# ADDENDUM TO JUNE 1990 CLOSURE PLAN FOR TANKS T-5 AND T-6
# JULY 1990

## 1.0 INTRODUCTION

The June 1990 revision of the RCRA closure plan for tanks T-5 and T-6 indicated that a record search would be performed to gain additional details on the tanks, their operating history and the characteristics of their contents. This information and modifications to the June 1990 plan made to accommodate this information are provided below.

PROPOSED SOIL SAMPLING LOCATIONS

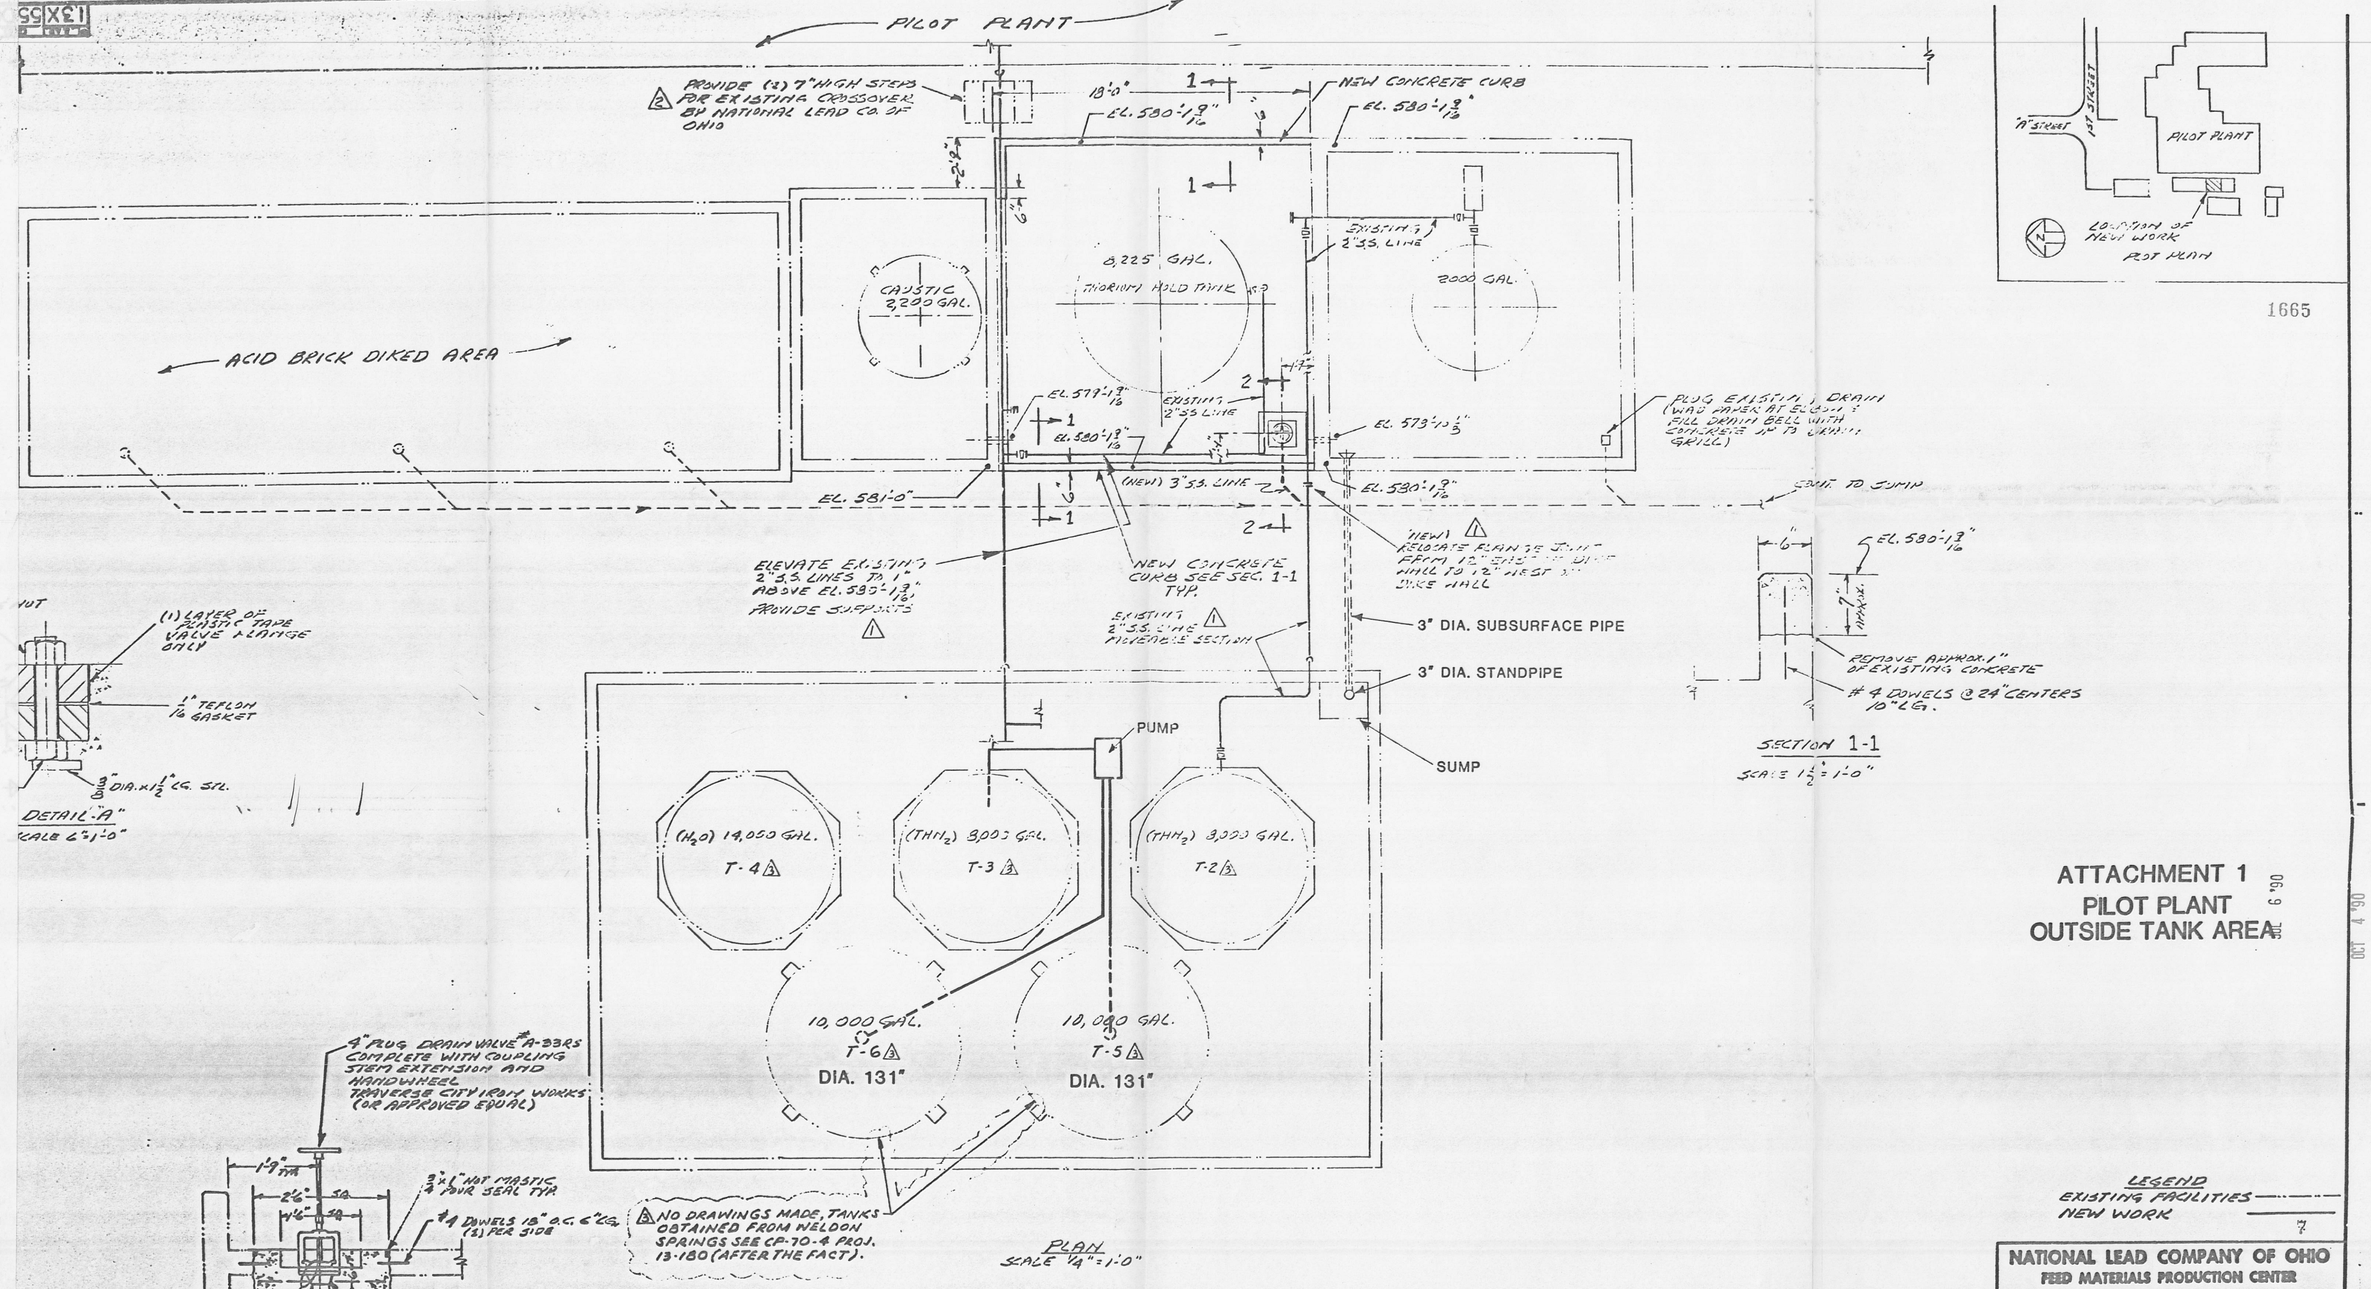
- Because the pad slopes to the east and any spills would have pooled against the east dike, the soil sample locations south and north of the pad as shown on Figure A-1 in the closure plan will be moved to the east of the pad at the locations shown on Attachment 4.

## ATTACHMENT 1
## PILOT PLANT
## OUTSIDE TANK AREA

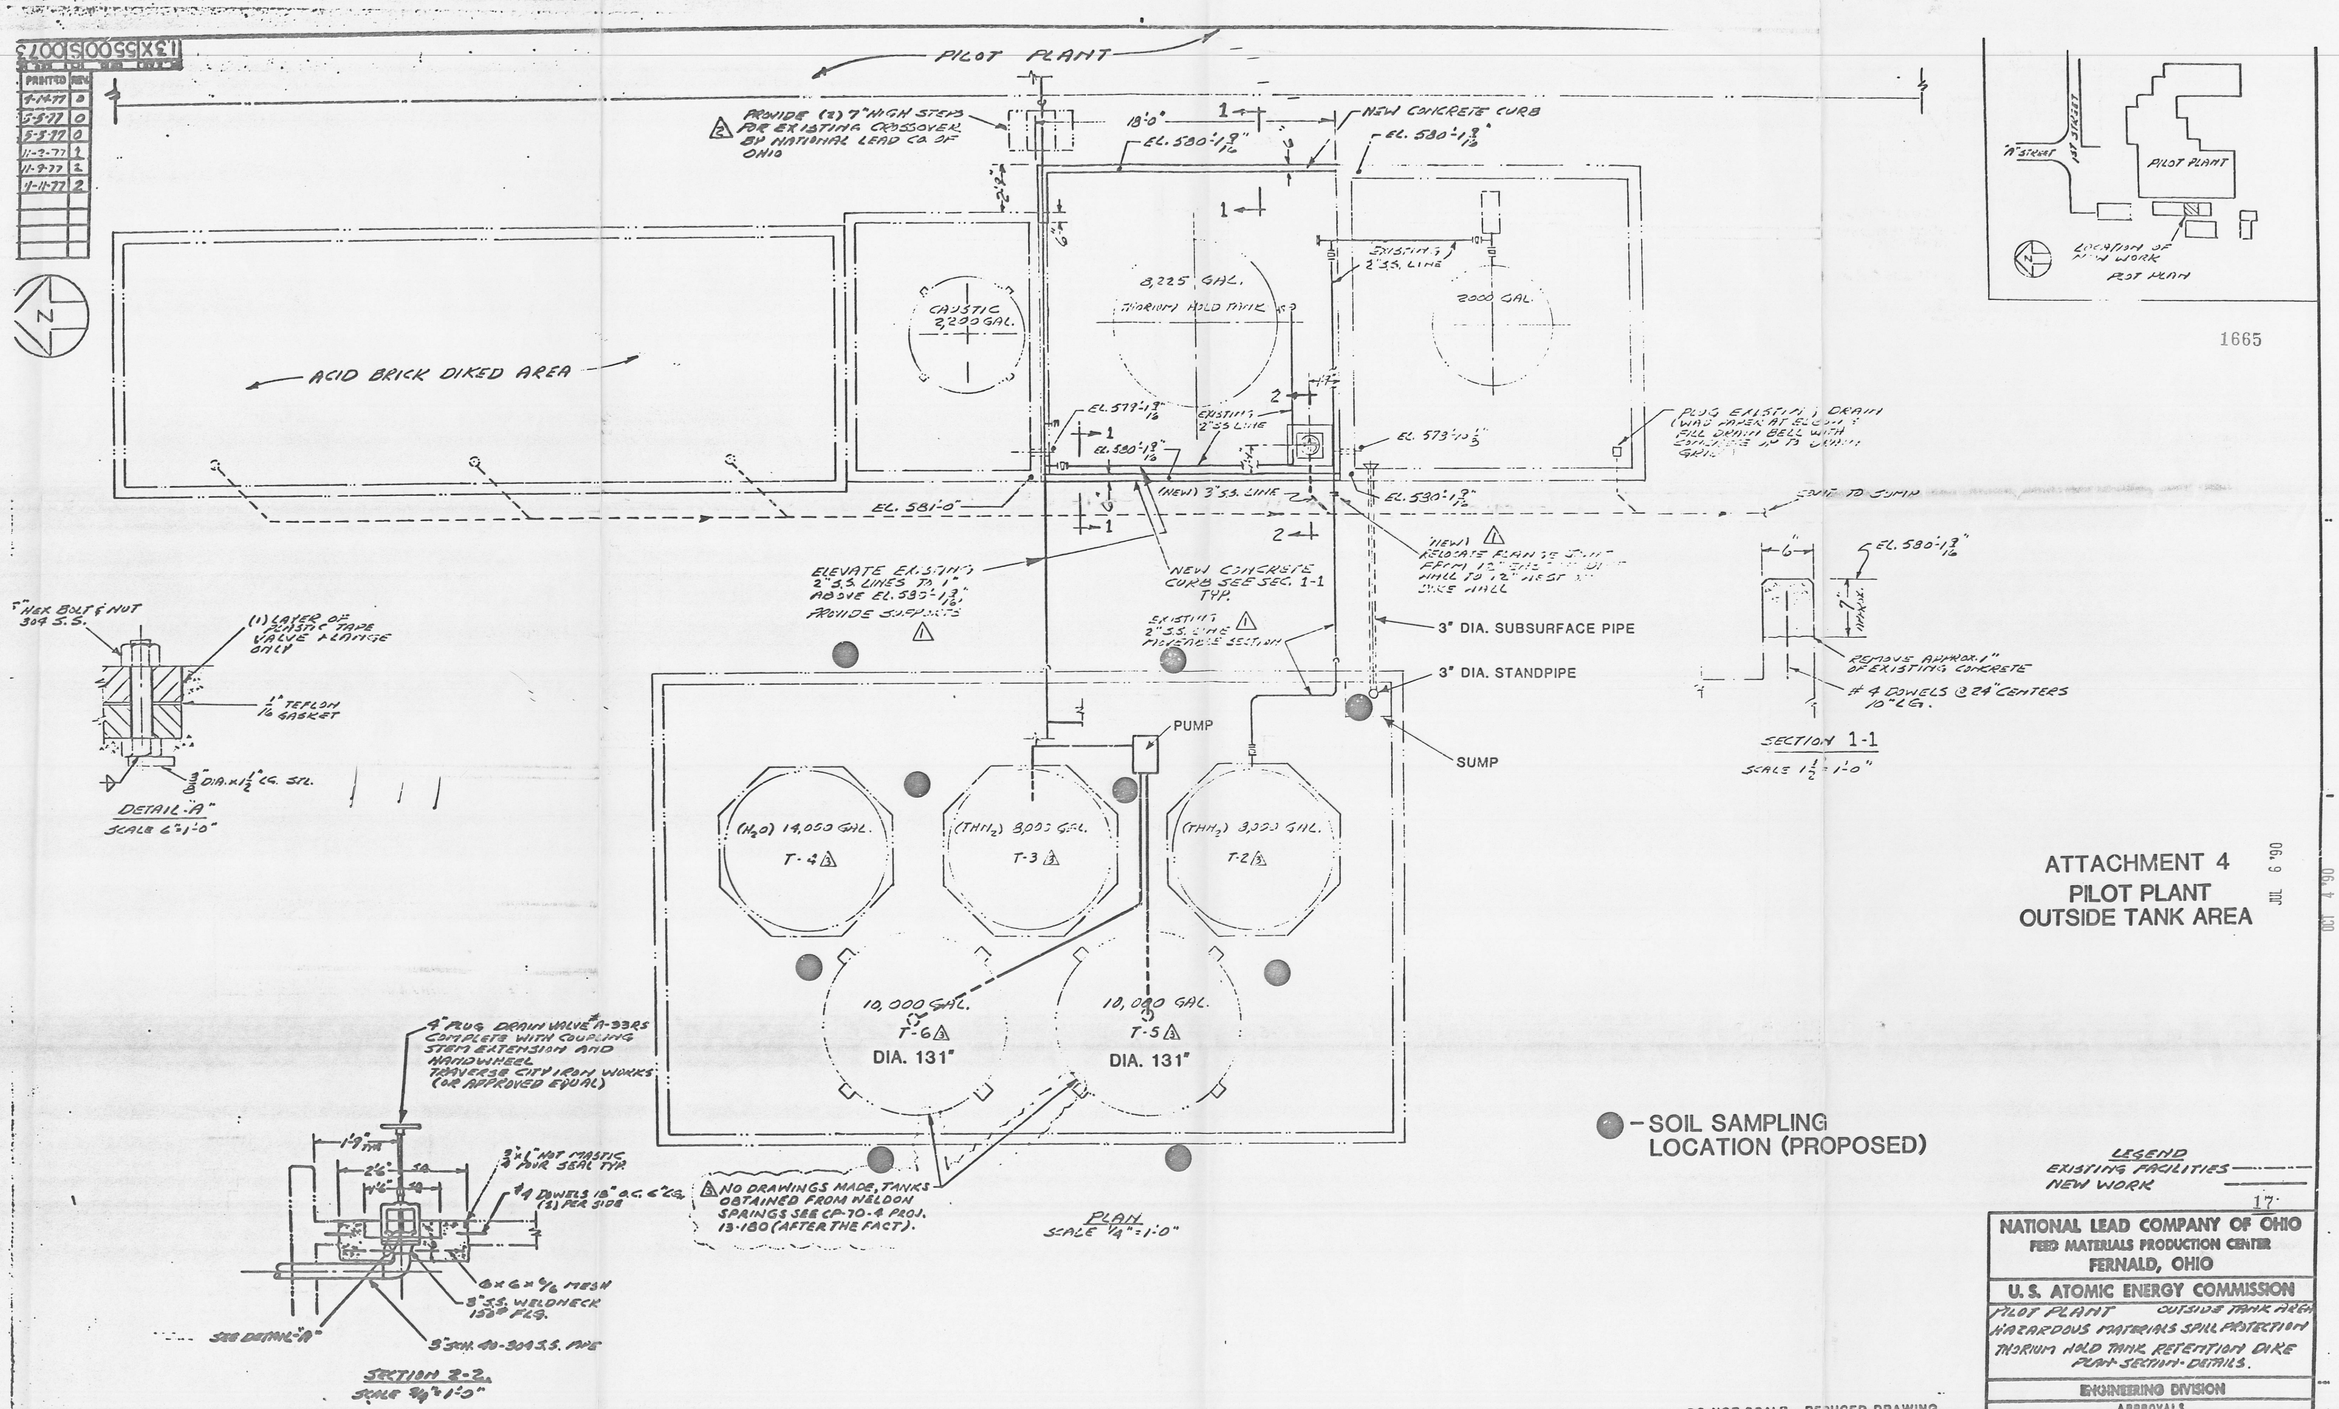
Attachment 1 to this addendum shows the locations of the two tanks relative to the Pilot Plant and the other tanks in the containment area. The drawing has been amended (relative to Figure 2 in the revised closure plan) to show the current configuration of the piping and pump associated with T-5 and T-6, the diameters of the tanks and the location of a shallow concrete sump and associated piping in the southeast corner of the containment pad.

The containment pad slopes gently toward the southeast, toward the sump shown on Attachment 1. The sump extends to approximately one foot below the surface of the pad and appears to have been cast in place with the containment pad. Centered in the sump is a three-inch diameter vertical standpipe that extends from near the sump bottom to approximately the top of the containment dike. The standpipe is open at the top and connected to a 90° elbow near the bottom of the sump. The elbow is connected to a three-inch diameter pipe that passes through the east dike and just below the ground to open to the brick-lined containment pad just to the southeast of tank T-2 (see Attachment 1). The height of the standpipe would prevent entry of fluid from the T-5/T-6 containment pad into the pipe. However, the piping permitted the additional containment capacity of the pad to the southeast to be used if necessary (due to catastrophic tank failure, for example) by removing the standpipe from the elbow. There is no documentation to suggest nor do historical accounts indicate that the standpipe was ever removed. Thus, the pad to the southeast is not considered to be part of the T-5 and T-6 hazardous waste management unit.

As can be noted on Attachment 1, the two bulk solvent storage tanks are connected by piping via an electrically operated pump to tank T-3. According to historical documentation, tank T-3 was emptied of thorium nitrate and the current piping installed to permit T-3 to serve as emergency containment in case of operating problems with or failure of tanks T-5 and T-6. The inspection plan for T-5 and T-6 (contained in the Pilot Plant Hazardous Waste Storage procedures and records document maintained at the Pilot Plant) specified that in case of leaks or other evidence of containment failure, the contents of the tank of concern would be transferred to T-3 if repairs could not be made with the contents in place.
